ST. TAMMANY PARISH

Addendum No.: 2

Bid#: 24-35-2

Project Name: Diversified Water Well Pretreatment System

SHEET NO.
C-001
SHEET 12 OF 92

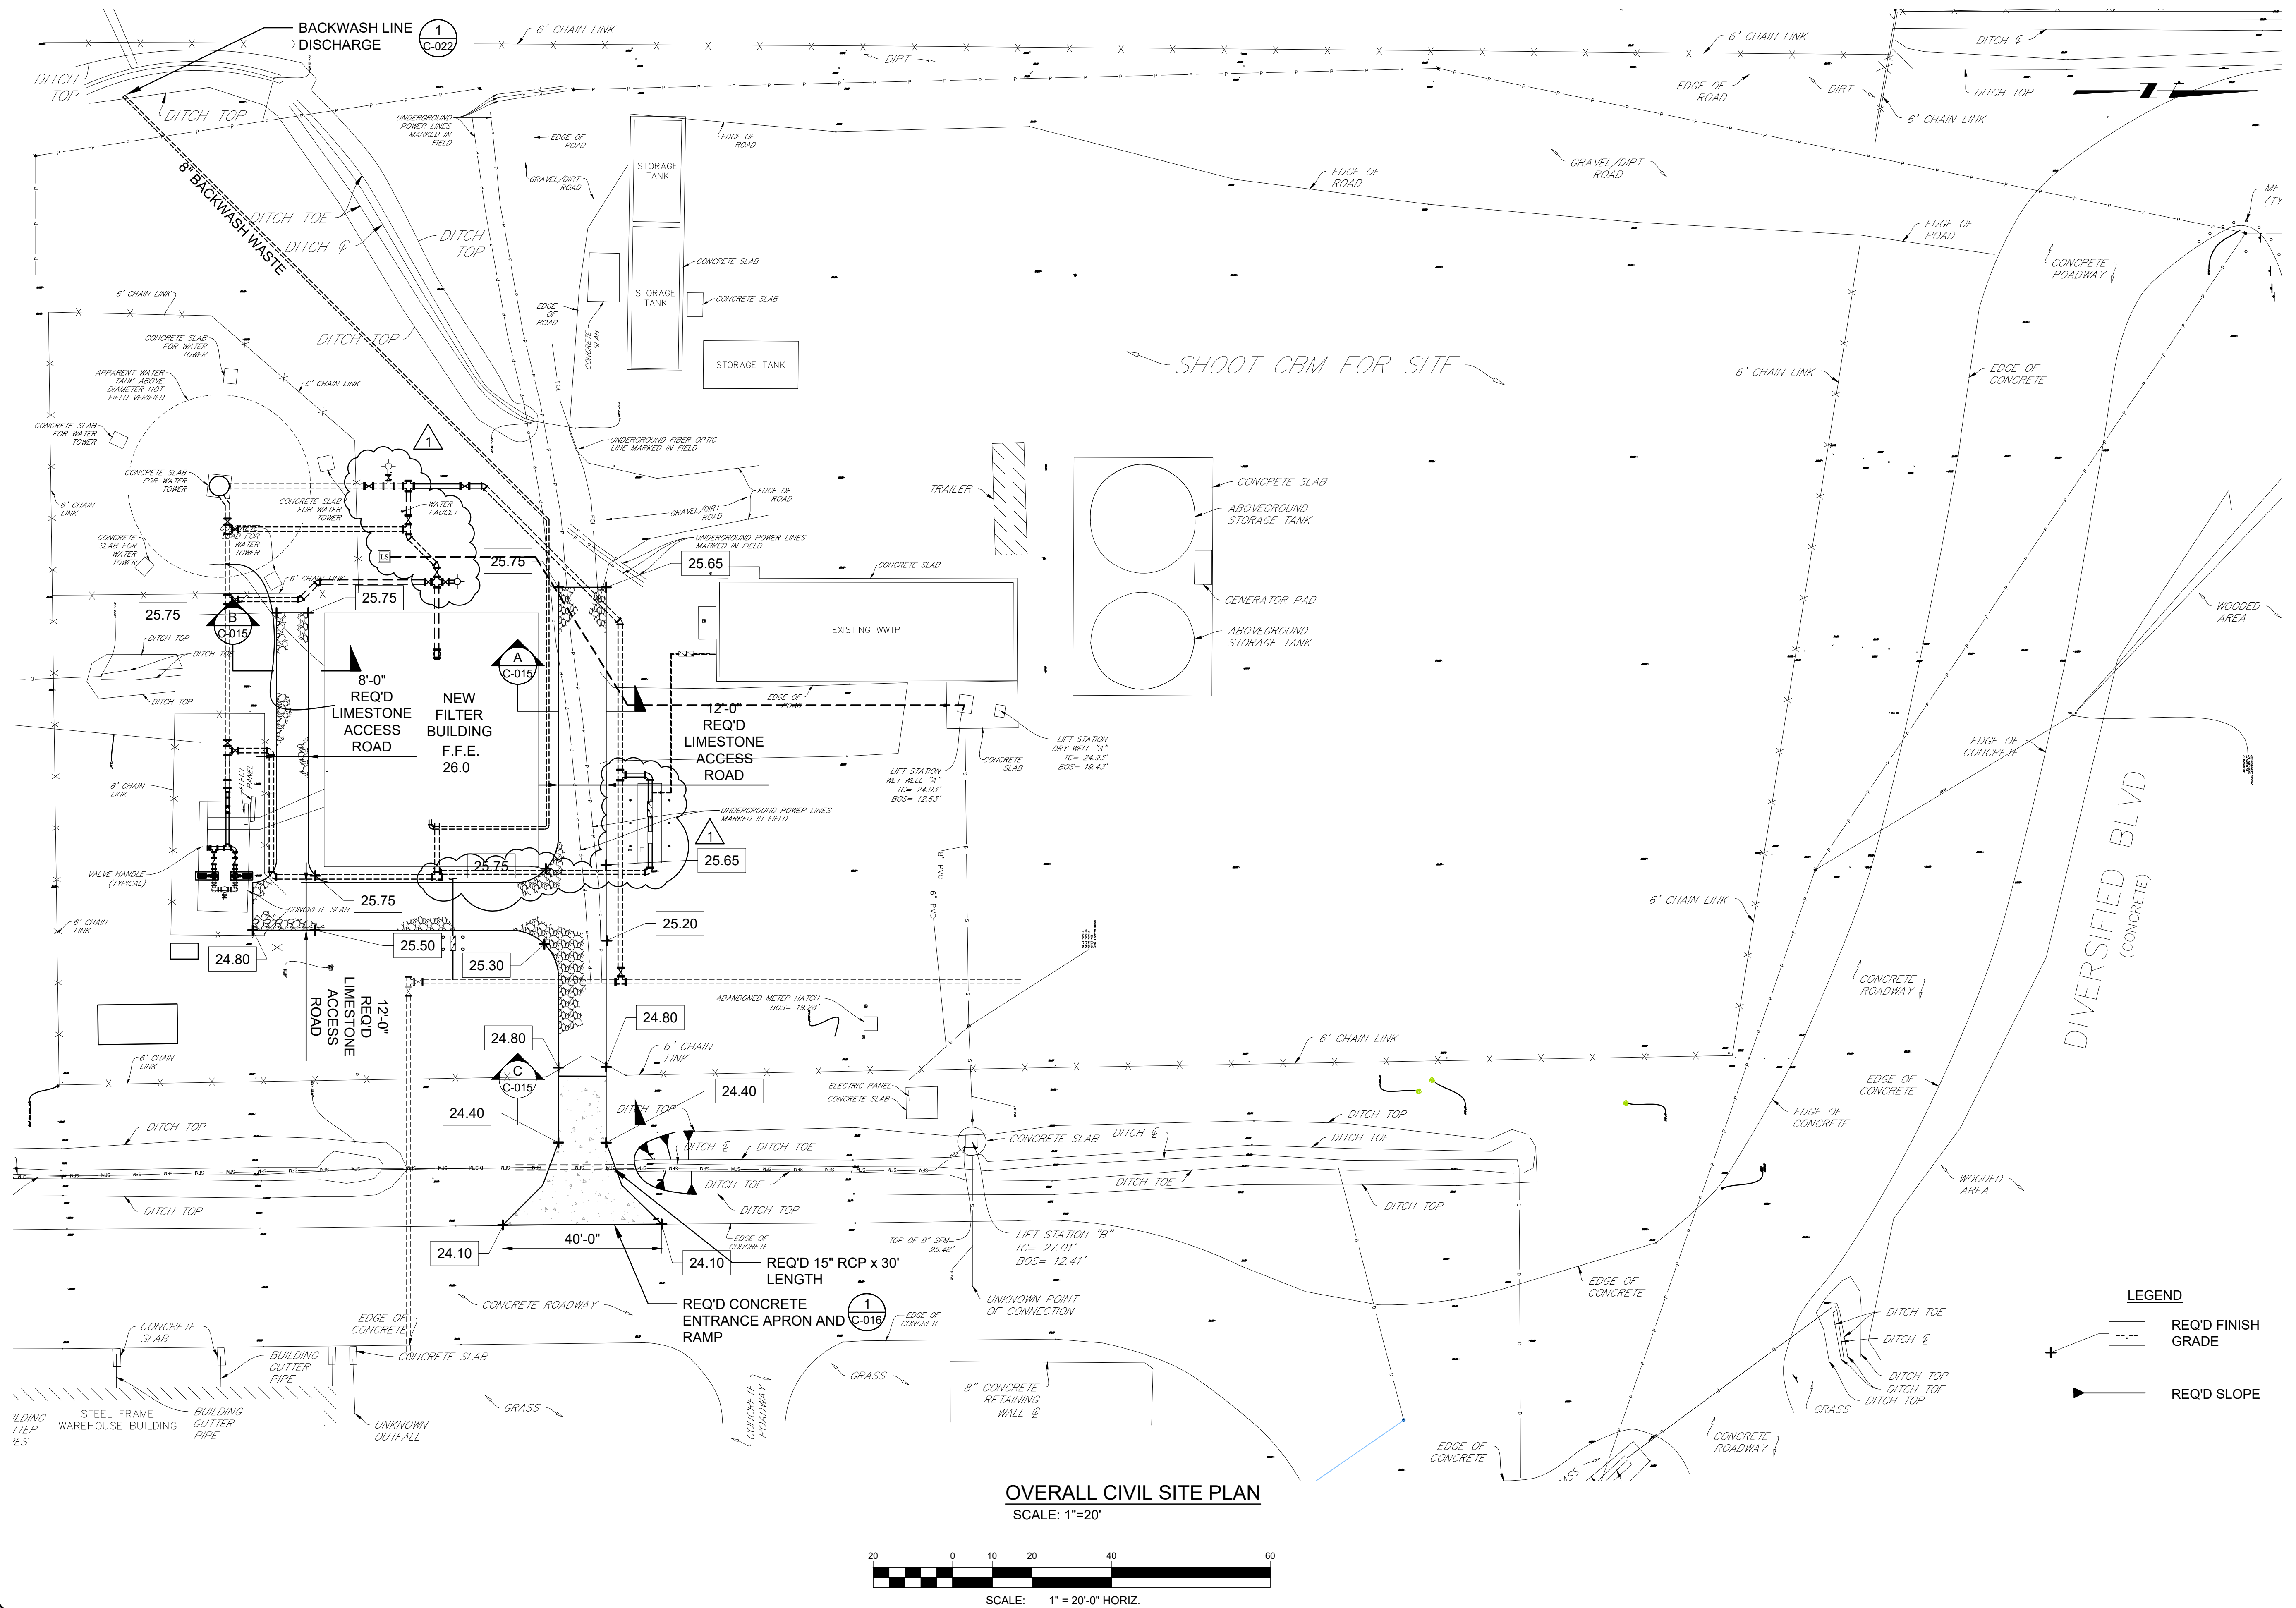
32. **Replace** Plan Sheet C-001 Detailed Site Plan with the attached revised Sheet C-001, revised to show adjusted location of Door #102B in Chemical Storage Room and Note 1 added to clarify required yard piping.

SHEET NO.
C-002
SHEET 13 OF 92

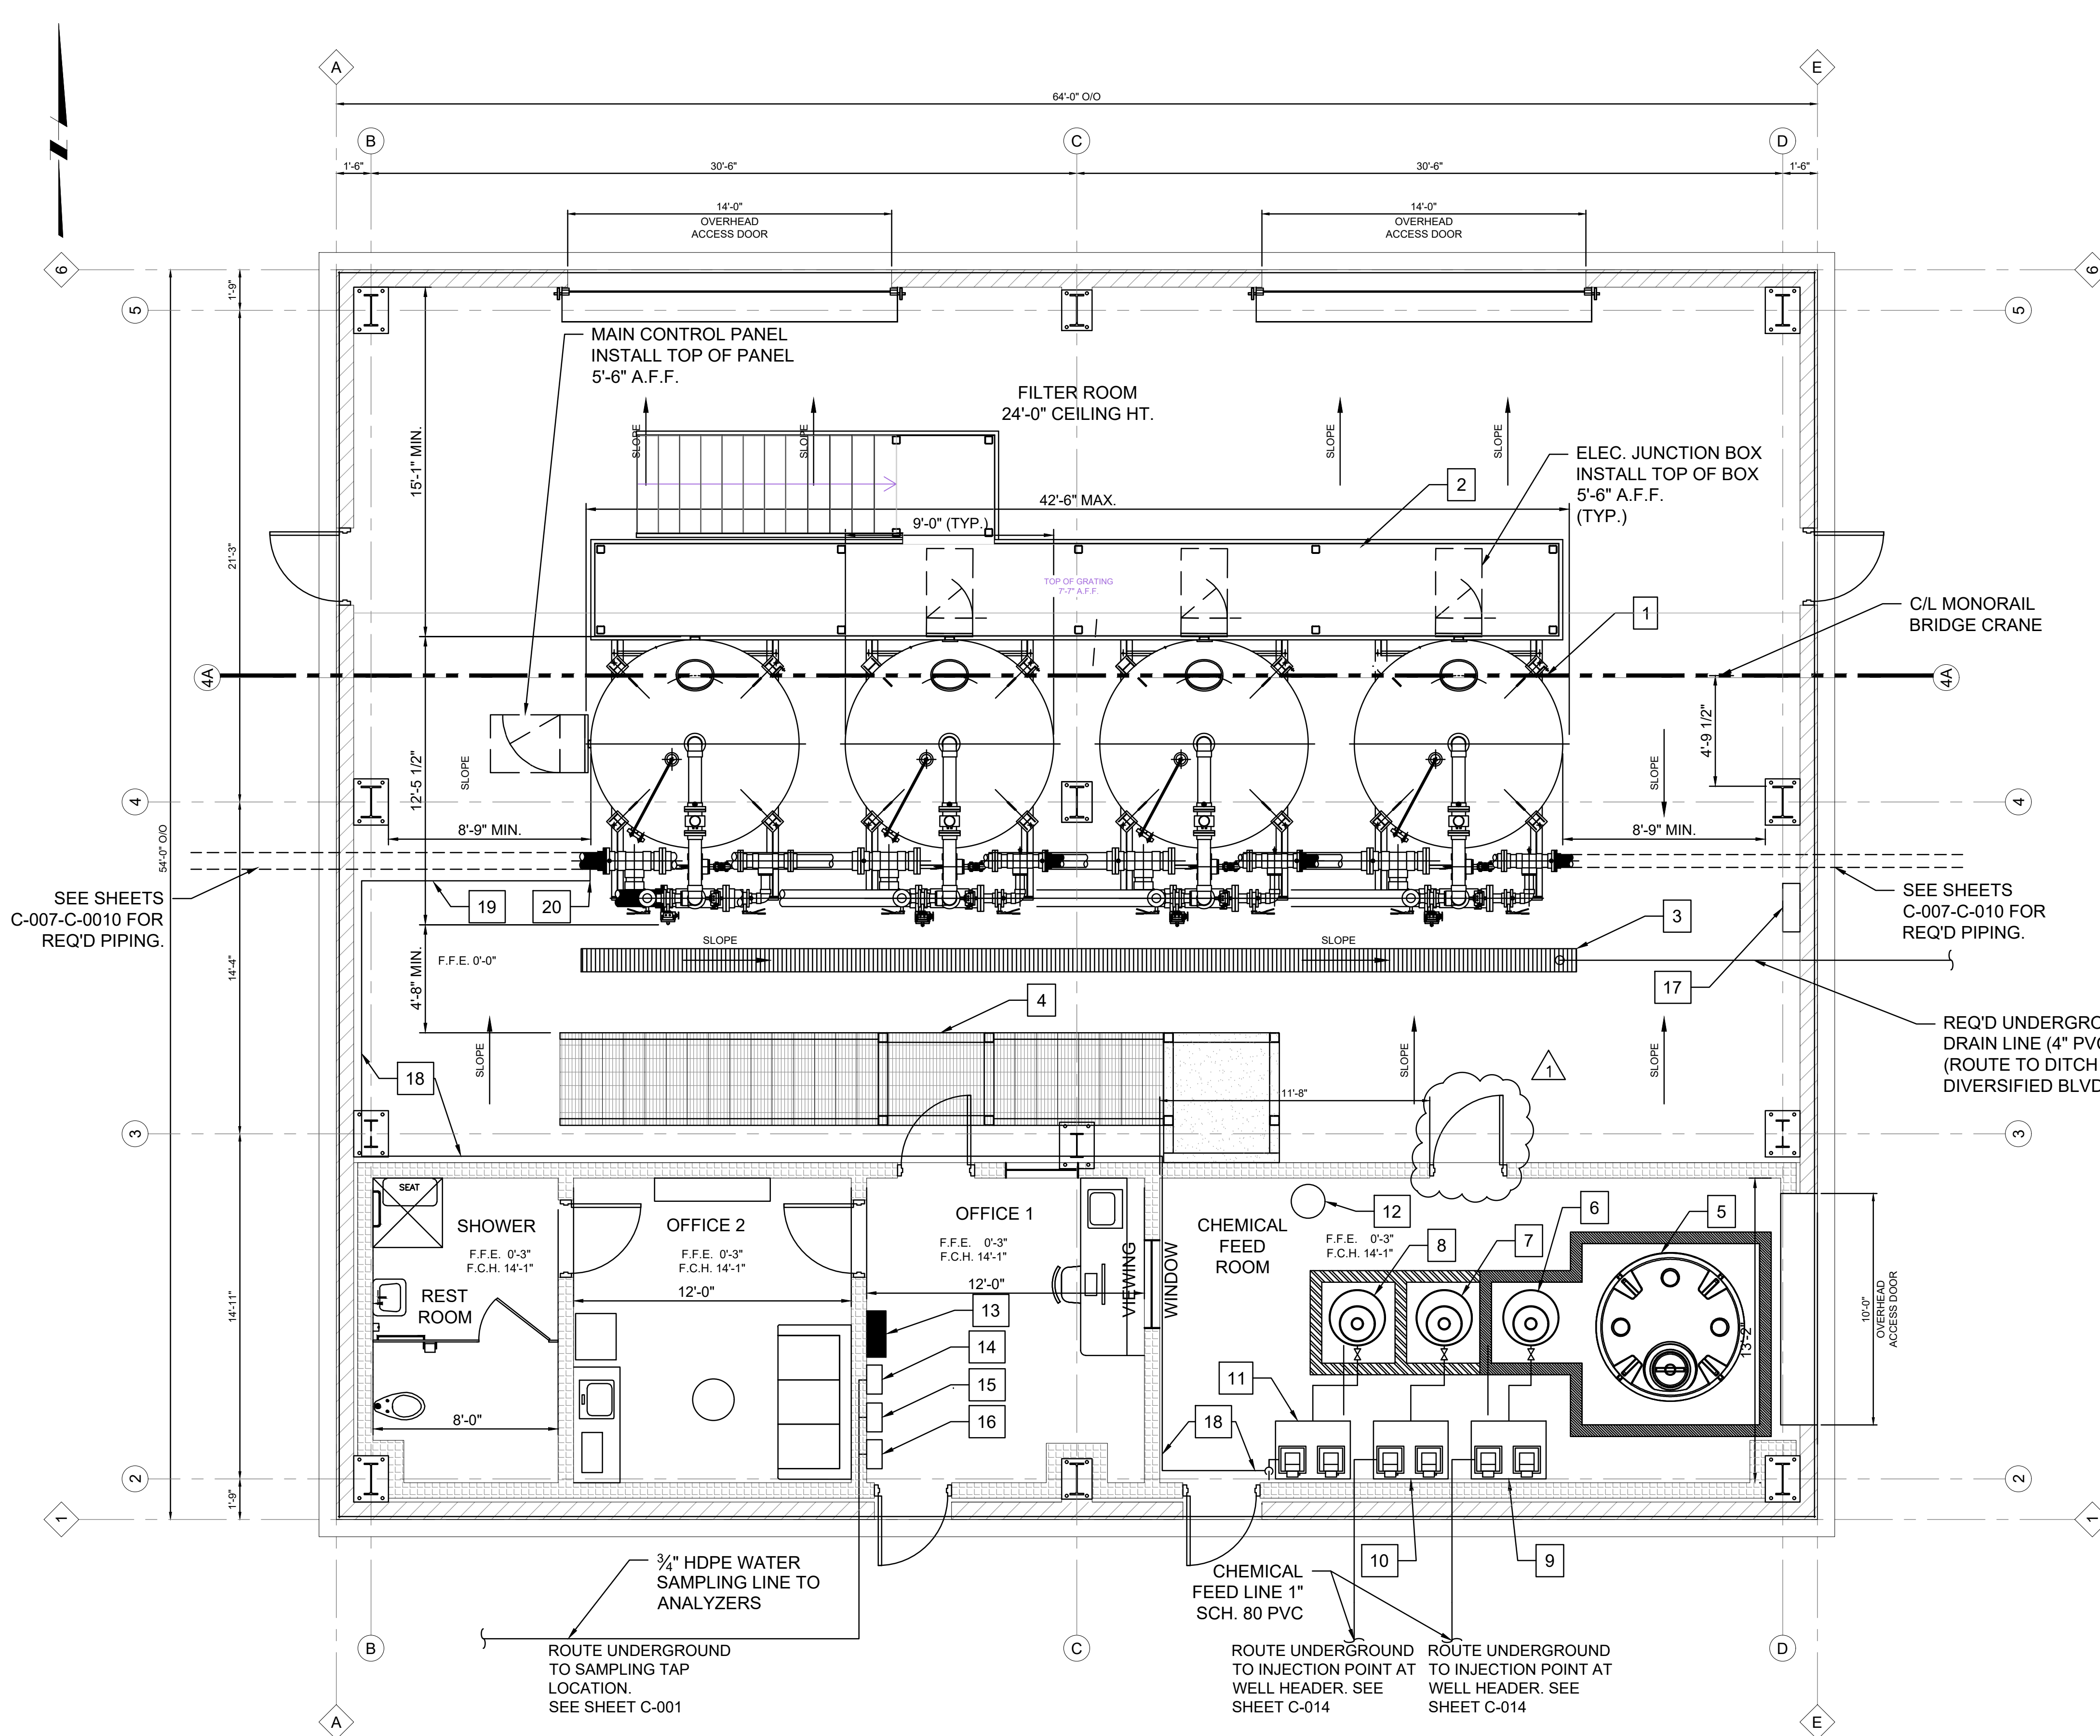
33. **Replace** Plan Sheet C-002 Overall Civil Site Plan with the attached revised Sheet C-002, revised to match the yard piping layout shown on Sheet C-001.

FILTER PROCESS FLOOR PLAN

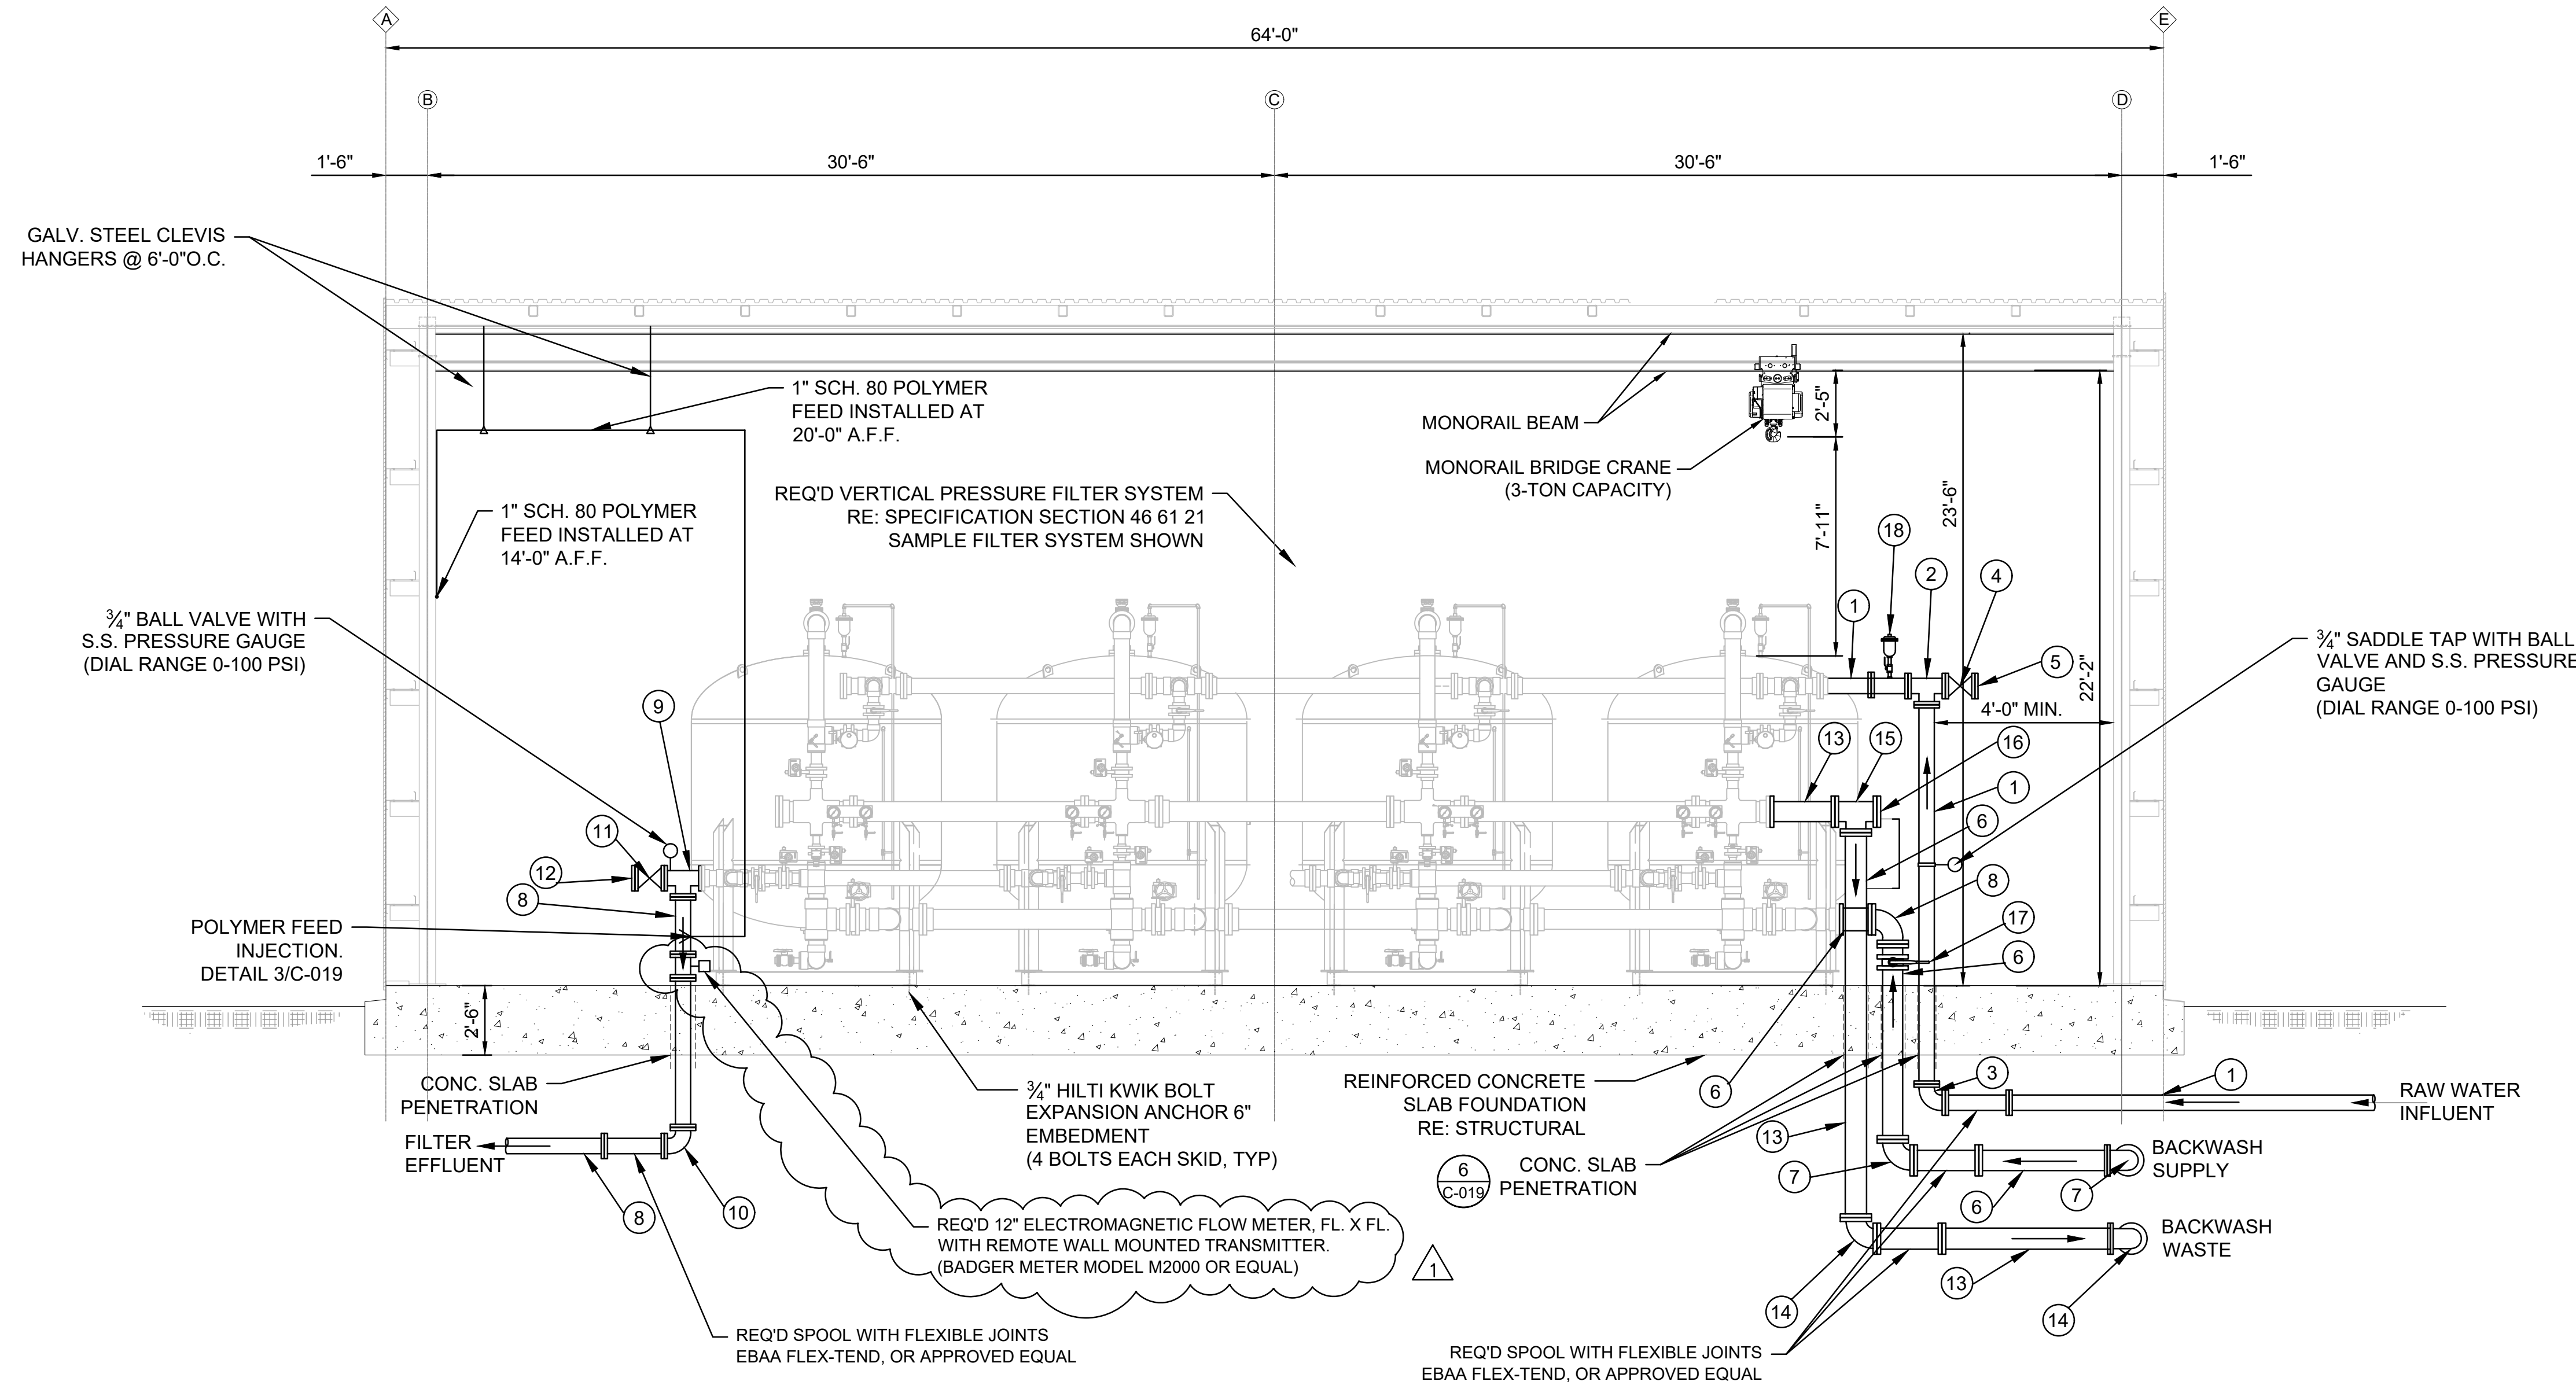
34. **Replace** Plan Sheet C-004 Filter Process Floor Plan with the attached revised Sheet C-004, revised to include the adjusted Door #102B location, to delete the Keynote No. 21, 12,000 BTU ductless mini-split a/c system, and to delete the entire Note at bottom right corner of sheet regarding A/C system.
